Access Compliance Report

Public Rights-of-Way

Intersection ID: 4576	Main Street: ROCKMEADOW_DR	Cross Street: TRINITY_RD	Location: SW
ADA ID: 19D3A8778EE5	Ramp Type: Perp	Initial Pass/Fail: Fail	Overall Compliance: No
		Severity Score: 12.5

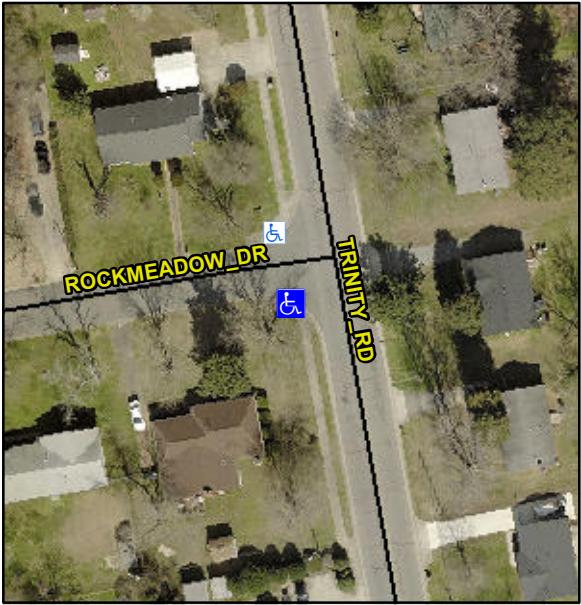
Codes/Mitigation Info/Possible Solution			Field Measurements/Component Compliance		
	Possible Solutions:		Compliance	Description	Data
	Remove & Replace Entire Ramp.		No	Ramp Length (in)	61.0
			Yes	Ramp Width (in)	48.0
			N/A	Flare Type LT	N/A
			N/A	Flare Slope LT (%)	N/A
			N/A	Flare Traversable LT?	N/A
			N/A	Landing Length (in)	N/A
			N/A	Landing Width (in)	N/A
			N/A	Landing Slope (%)	N/A
			N/A	Landing X Slope (%)	N/A
<p>Surveyor Notes:</p> <p>N/A</p> <p>PROW/ADA:</p> <p>R304.2.2</p>			N/A	Flare Type RT	N/A
			N/A	Flare Slope RT (%)	N/A
			N/A	Flare Traversable RT?	N/A
			N/A	DWS Provided?	N/A
			N/A	DWS Contrast?	N/A
			N/A	DWS Length (in)	N/A
			N/A	DWS Full Width?	N/A
			N/A	DWS Offset (in)	N/A
			N/A	Shared Landing?	N/A
			N/A	Gutter Ponding?	N/A
			N/A	Gutter Lip Ht (in)	N/A
			N/A	Painted X Walk1?	No
				X Walk 1 Direction	To N
			N/A	X Walk 1 Width (in)	N/A
				X Walk 1 Slope (%)	2.7
				X Walk 1 X Slope (%)	1.2
